SUBJECT:  
Davis-Besse Nuclear Power Station, Unit No. 1  
Docket No. 50-346, License No. NPF-3  
License Amendment Request – Proposed Post-Shutdown Emergency Plan

Subject: Request to Revise the Davis-Besse Nuclear Power Station Emergency Plan

ONSHIFT EMERGENCY ORGANIZATION

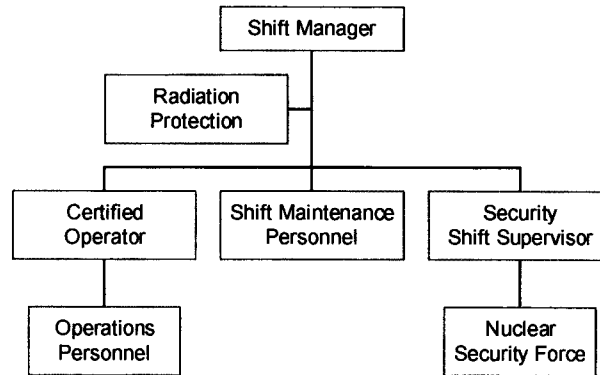
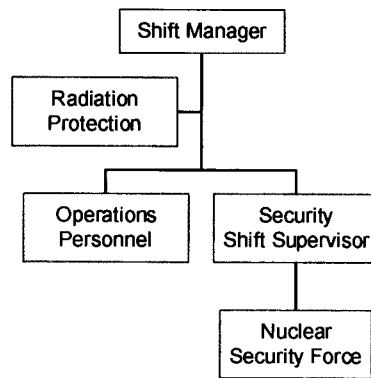
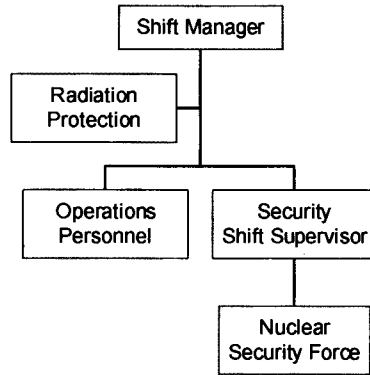
<b>Emergency Plan Section</b>	<b>Before (Rev. 33)</b>	<b>After (Pending Revision Number)</b>	<b>Reason for Change</b>
Figure 5-1, ONSHIFT EMERGENCY ORGANIZATION		Removed Chemistry, Shift Engineer (STA), Onshift Maintenance and Unit Supervisor	Modified to reflect on-shift organizational changes.
Figure 5-2, Emergency Response Organization (Page 1 of 10)		Removed Emergency Director Advisor	Modified to reflect ERO changes.
Figure 5-2, Emergency Response Organization (Page 2 of 10)		Removed Recovery Advisor. Eliminated Core Damage Assessment function from the TSC Engineering Manager.	Modified to reflect ERO changes.  After docketing of the certifications of permanent cessation of power operations and permanent removal of fuel from the reactor vessel, the 10 CFR 50 license will no longer authorize reactor operation or emplacement or retention of fuel in the reactor vessel. As a result, core damage assessment is no longer needed.

**Emergency Response Organization**  
Page 3 of 10

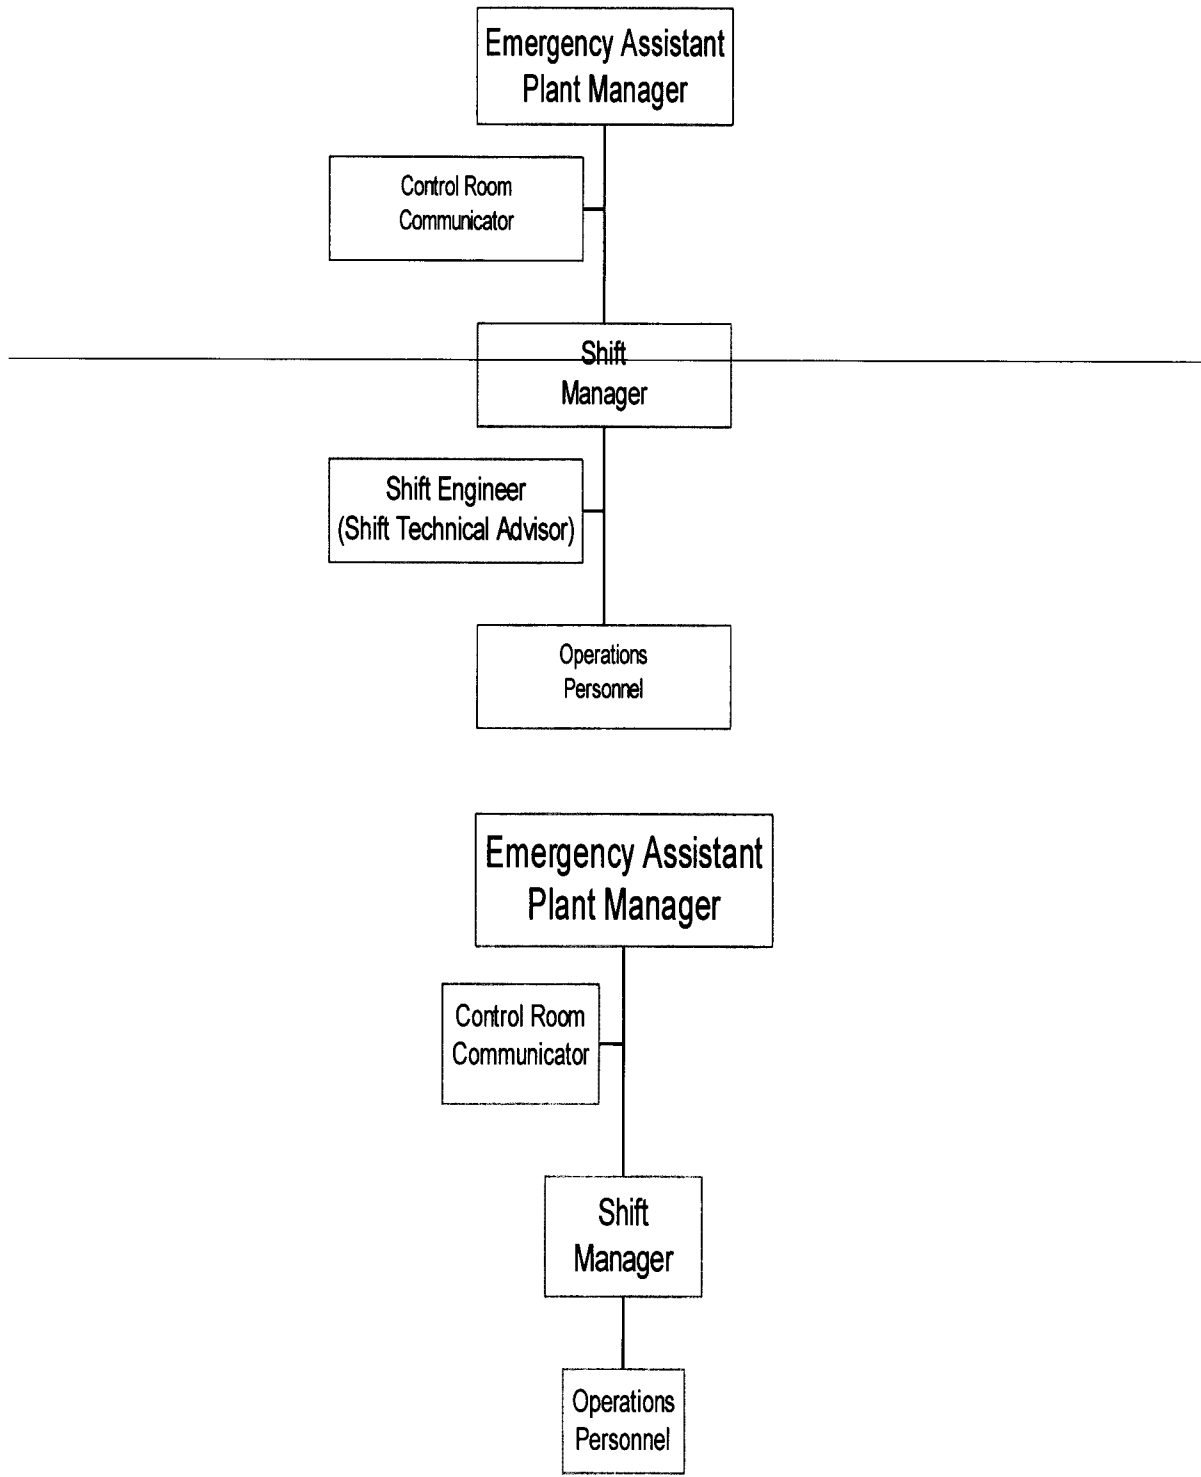
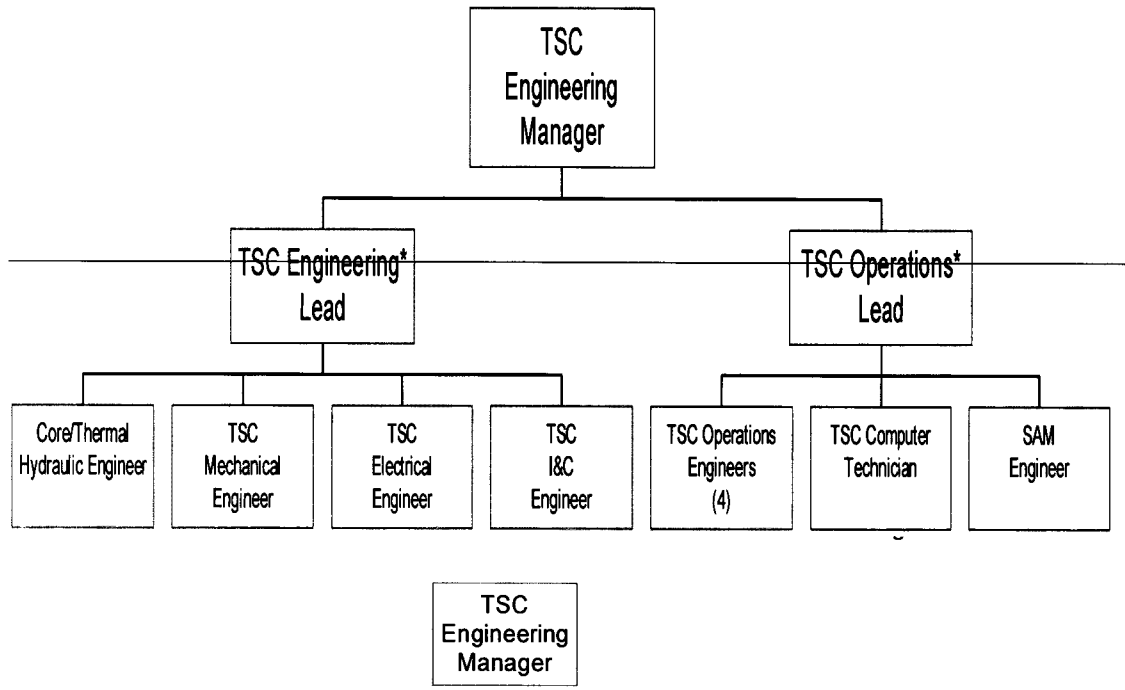
Figure 5-2, Emergency Response Organization (Page 3 of 10)		Removed Shift Engineer (STA)	Modified to reflect ERO changes.
Figure 5-2, Emergency Response Organization (Page 4 of 10)		Removed TSC Engineering Lead, TSC Operations Lead, Core/Thermal Hydraulic Engineer, TSC Mechanical Engineer, TSC Electrical Engineer, TSC I&C Engineer, TSC Operations Engineers, TSC Computer Technician, SAM Engineer	Modified to reflect ERO changes.
Figure 5-2, Emergency Response		Removed OSC System Engineers, RP Briefer/Debriefer, Assistant OSC Manager, OSC Team	Modified to reflect ERO changes.

**Emergency Response Organization**  
Page 8 of 10

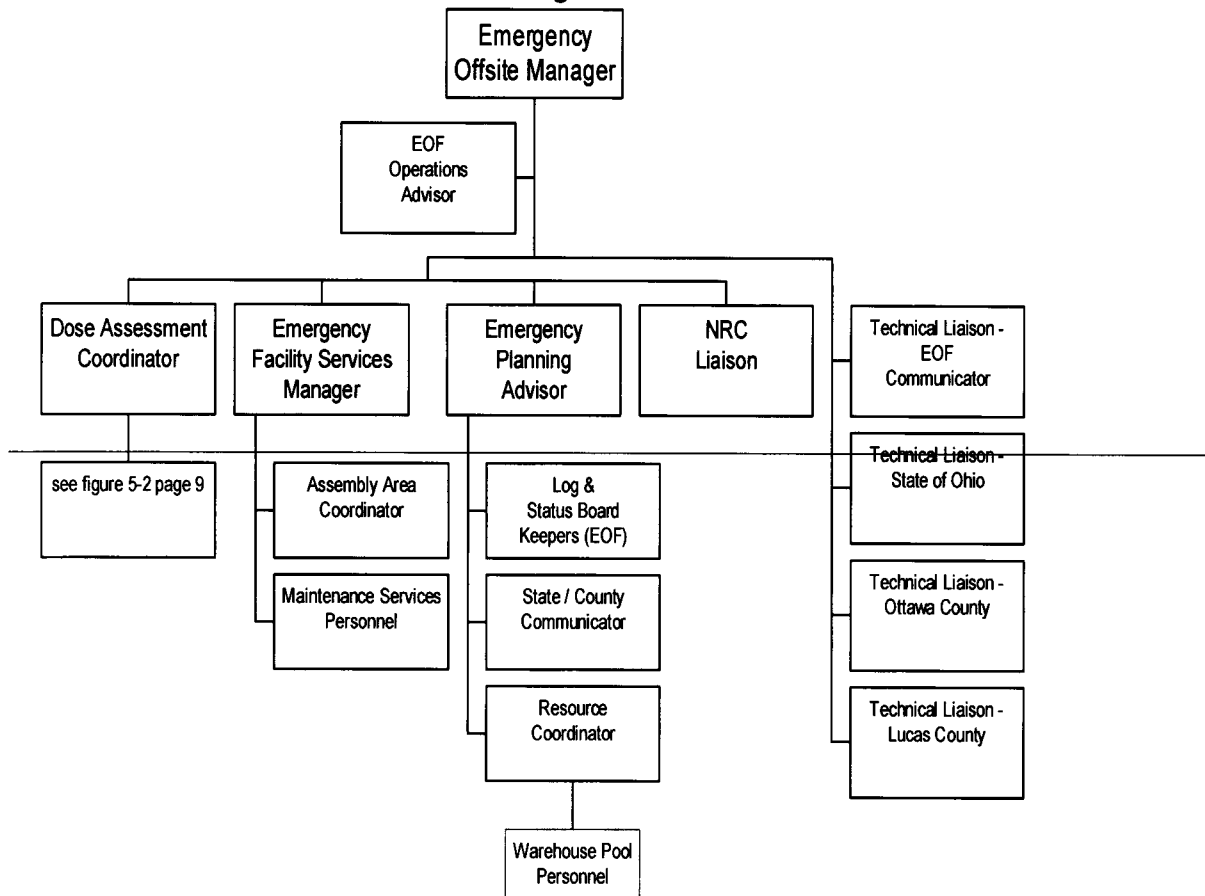
Emergency Plan Section	Before (Rev. 33)	After (Pending Revision Number)	Reason for Change
Organization (Page 6 of 10)		Briefer/Debriefer, Operations Personnel	
Figure 5-2, Emergency Response Organization (Page 8 of 10)		Removed EOF Operations Advisor, Emergency Facilities Services Manager, Assembly Area Coordinator, Maintenance Services personnel, Log and Status Board Keepers, Resource Coordinator, NRC Liaison, Warehouse pool personnel	Modified to reflect ERO changes.
Figure 5-2, Emergency Response Organization (Page 9 of 10)		Reduced Dose Assessors from 2 to 1	Modified to reflect ERO changes.
Figure 5-2, Emergency Response Organization (Page 10 of 10)		Removed Public Affairs Duty Officer, JIC Writer, News Statement Coordinator, JIC Communicator, PR Communicator, Audio/Visual Coordinator	Modified to reflect ERO changes.
